Notice: Request For Information

Great Australia Mine

On 27 October 2014 the Department of Environment and Heritage Protection (DEHP) issued CopperChem a Notice Requiring Further Information (RFI) (DEHP Ref: 101/0088742, STAT877) relating to the CopperChem Environmental Evaluation report submitted on 13 October 2014. This RFI has been prepared to provide further comment with regards to the requirements as specified in Section B of the DEHP Notice.

Figure 2: Locations of down-gradient groundwater bores and the Cloncurry River targeted for a sampling and analysis programme to support investigations on impacts caused (if any) to Environmental Values

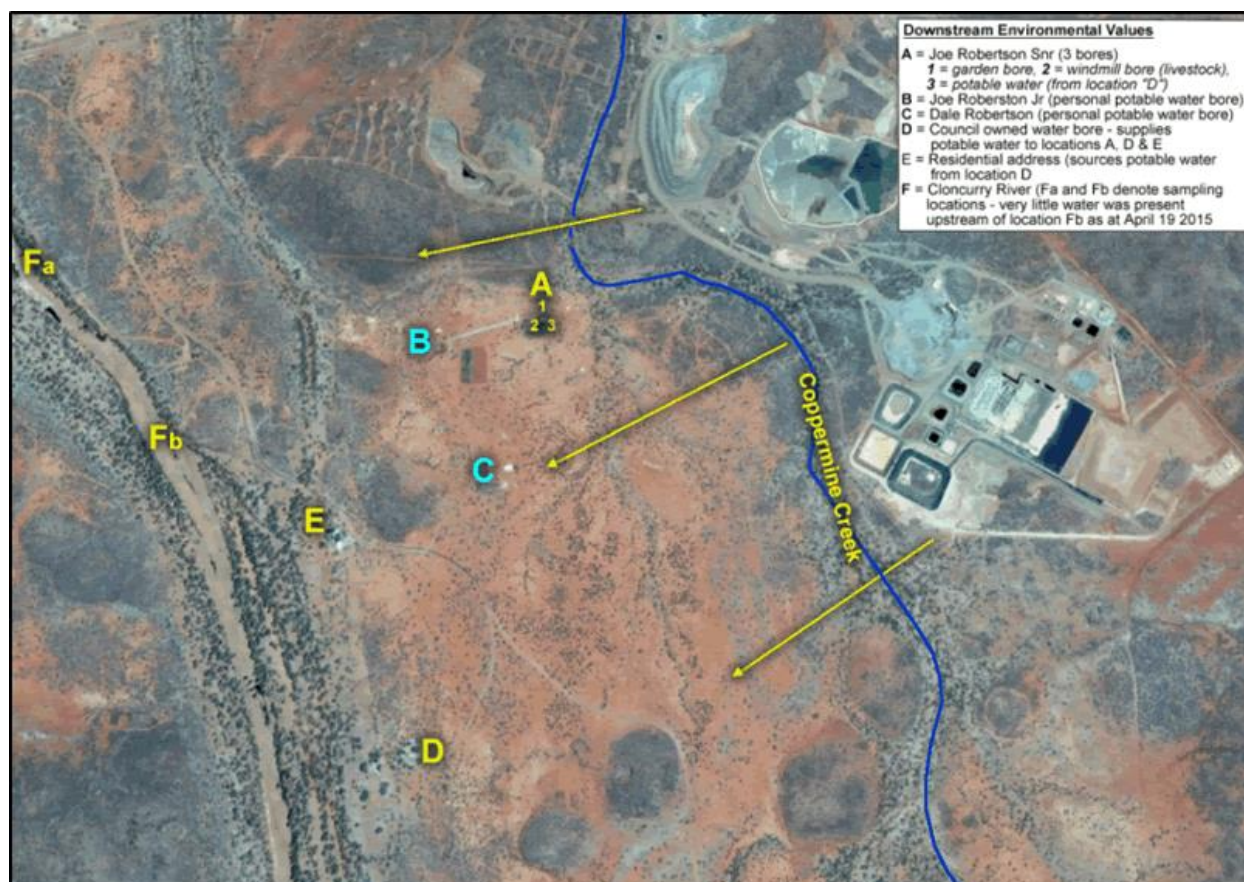
CopperChem Ltd is required to assess the impacts on the additional environmental values under requirement 1a (sic).

To further investigate the impacts (if any) caused to down-gradient EV's (identified in Table 3), CopperChem undertook a groundwater sampling and analysis programme targeting "off-lease" EVs. These included:

- Adjoining property groundwater bores (i.e. for livestock watering and human consumption); and
- Surface water from the Cloncurry River (i.e. supporting River Red Gum communities).

The location of the groundwater bores sampled and the locations of the sampling points in the Cloncurry River are shown in 2. Table 3 details the groundwater bores sampled and their current use.

Figure 5: Groundwater levels in OB1, OB10, OB18 and TSFOB7 following recharge events – groundwater level measurement (in meters below ground level (mBGL)) (right axis) and rainfall data (mm) (left axis)

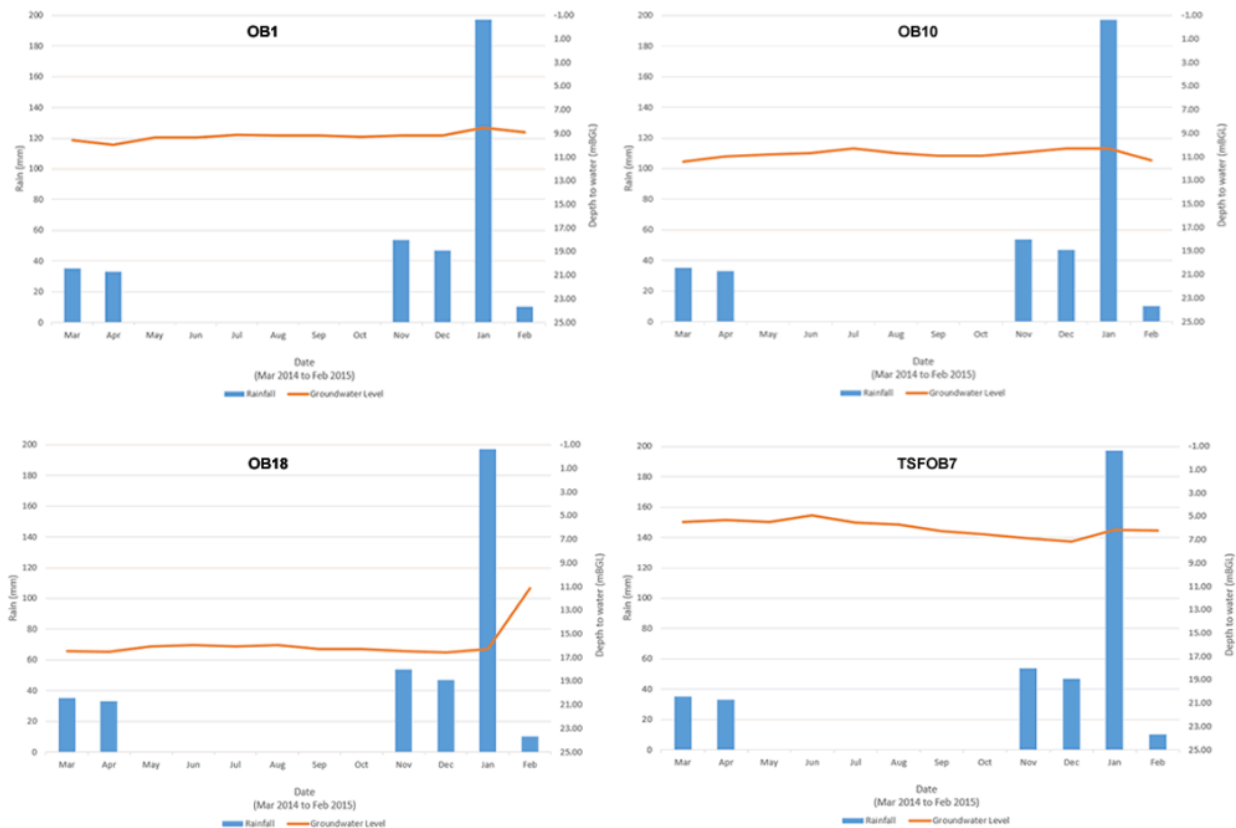
3. *Further information is required regarding the shallow ephemeral groundwater system at the site. CopperChem Ltd is required to provide details of the flow paths, including hydraulic gradients, of the shallow groundwater system and an assessment of the site geology to determine the degree to which structural geology (faults zones/ joints etc.) act as conduits enabling contaminant migration (sic).*

To better illustrate the variability in groundwater response in relation to recharge events (i.e. rainfall), Figure shows daily rainfall (measured in mm) received at GAM versus groundwater levels measured at bore OB1, OB10, OB18, TSFOB7 (from March 2014 to February 2015). These bore were selected, as it is believed, they are spatially representative of the area immediately down-gradient of the TSF and Heap Leach facility.

It can be seen from Figure that once the unsaturated zone becomes saturated during/following the wet season, in some instances there is a marked response (sometimes lag) in groundwater levels (i.e. OB18) to rainfall received; however, in other cases the response is much smaller (i.e. OB1 & TSFOB7) or inconsequential (i.e. OB10). The response of groundwater levels, following a rainfall event, is directly related to the aquifer material and conductivity.

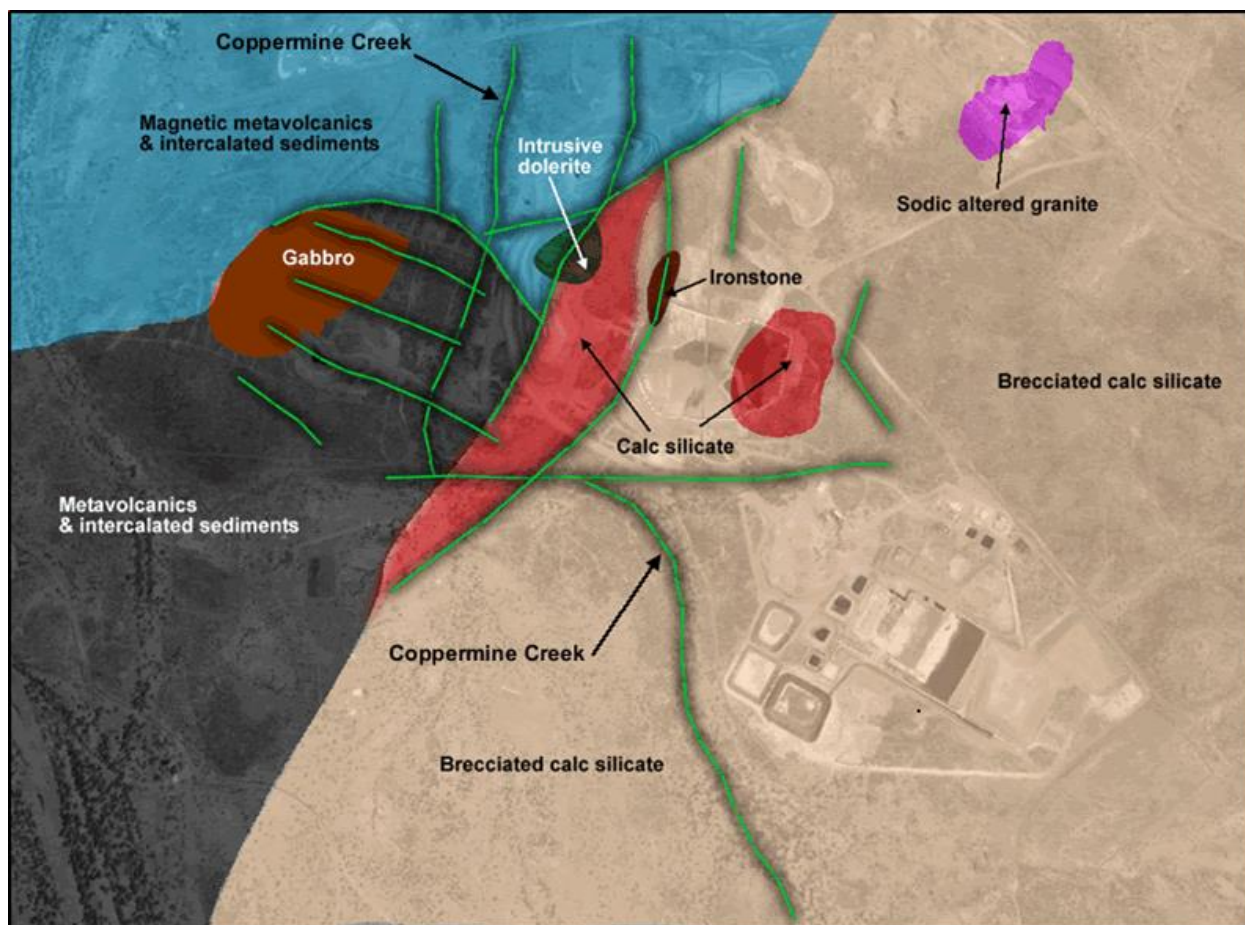
2. *The environmental report states that all open voids act as groundwater sinks and that the geology is laterally discontinuous. However, the environmental report also identified a fault line through the GAM Pit. CopperChem Ltd is required to provide further information as to the hydrological implications of this fault line (sic).*

With reference to Figure 6, AGE (2004) identified that the geological lineament oriented north-east, in the area of the TSF, is considered to be in an area of localised high transmissivity and groundwater flow. Therefore, it was suggested that this lineament had the potential to convey waters from the TSF towards Coppermine Creek. However in July 2014, CopperChem ceased operational inputs to the TSF, thus decreasing the possibility of any release from the TSF to down-gradient receptors.

In terms of the remaining geological lineaments promoting groundwater flow, this is largely unknown. Although such structures as faults can influence groundwater flow, this depends on the size of these features and the geology of which they intersect. Faults are not always preferential pathways for groundwater. For instance, and in many cases, fault networks can become filled with secondary precipitates originating from dissolved constituents in groundwater (i.e. carbonates, salts) or, as a result of the lithology, faults can be filled with fine-grained material. In a paper by Cannell and Davidson (1998) it was stated that many of the fractures and faults at GAM have been infilled by a calc-silicate assemblage. Fracture-filling of geological structure greatly impede groundwater storage, and flow, within in these features.

In the case of GAM, if faults did convey groundwater flow, then the direction of flow would be south-westerly. In consideration of this account and the contaminant limits specified in the EA, the quality of groundwater as measured from the alluvial aquifer, making up the Coppermine Creek, is compliant. For example, although Cu and Co show temporal [yet minor] exceedances (not surprising since this aquifer bisects two ore bodies), SO_4^{2-} concentrations are below 500 mgL^{-1} . Additionally, as DEHP have concerns regarding Co and Cu as potential contaminants in groundwater, groundwater quality from the alluvial aquifer indicate that the dissolved concentration of each of these transitional metals show temporal variability. For example, a particular sampling programme might show that the concentration for each is lower than the EA contaminant trigger limit; whereas a follow-up sampling programme might show that the concentration has exceeded the EA contaminant trigger limit. In most instances where these metals have exceeded the EA contaminant trigger limit, the concentrations are at or near to the laboratory Limits of Reporting (LoR)¹. This does not necessarily indicate that these are harmful to groundwater receptors or users; but the inconsistency in results does indicate the [expected] natural variability of water soluble Co and Cu in the region.

Figure 7: Generalised schematic of a “losing” stream such as the Cloncurry River and Coppermine Creek. Note: the hydraulic disconnect between groundwater and surface water (EPA, 2015).

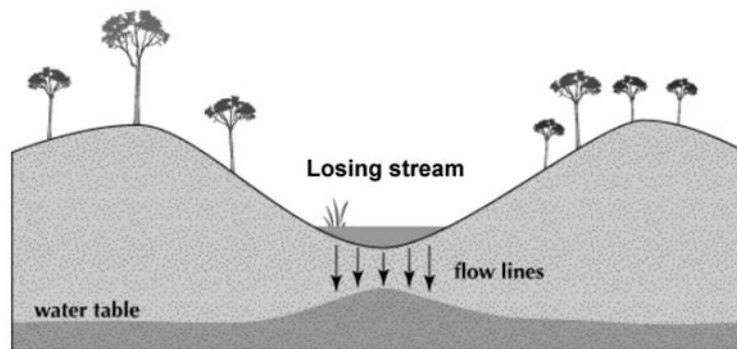
The environmental report presents insufficient information to identify the locations and types of groundwater aquifers at the Great Australia Mine. CopperChem Ltd is required to address this requirement of the Notice (sic).

- (iii) An unconfined aquifer making up the alluvium of the Coppermine Creek. This aquifer is laterally constrained; extending no more than approximately 30m from the creek bed. These aquifers undergo saturation for only a very short time after a surface flow event. Some authors have the view that this aquifer can be perched; however, there is no substantial evidence to support this. The aquifer materials that underlie the Coppermine Creek have groundwater associated with them all year around, and these aquifers undergo recharge following a surface flow event. However, surface water systems such as the Coppermine Creek (and Cloncurry River) are known as “losing systems” (Figure) and dry up soon after a surface flow event.

These systems are not in direct hydraulic connection with groundwater. For instance, during the surface flow events of 2014 and 2015, although there was water in the Coppermine Creek, there was a ~7 metre separation between surface water and groundwater. Water in these creek systems lose their water slowly through infiltration, therefore the separation between the base of the creek and groundwater does not undergo saturation.
